Comments on

Pines FS_Figures_November 29_2012

By Larry Jensen PINES Group

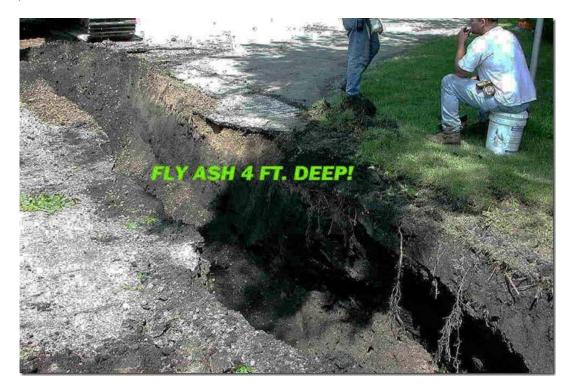
"While there is no information as to the percent CCBs in subsurface soils, the majority of potential

CCB's appear to be present in subsurface soils, perhaps extensively. A citizen of Pines took the following picture during road work that shows a seam of material, potentially bottom ash, approximately 4 feet thick. Remediation actions must be cognizant of this potential.

It was stated in the Remedial Investigation Report of March 5, 2010, in the Potential Human Receptors Section (page ES-3) that, "Construction workers may potentially contact surface and subsurface CCB's directly via incidental ingestion and dermal contact." It should also be stated that gamma-ray / X-ray exposure may occur.

The Town of Pines is investigating installation of a sewer network. Workers doing this work may encounter radioactive CCB's that could be potentially hazardous.
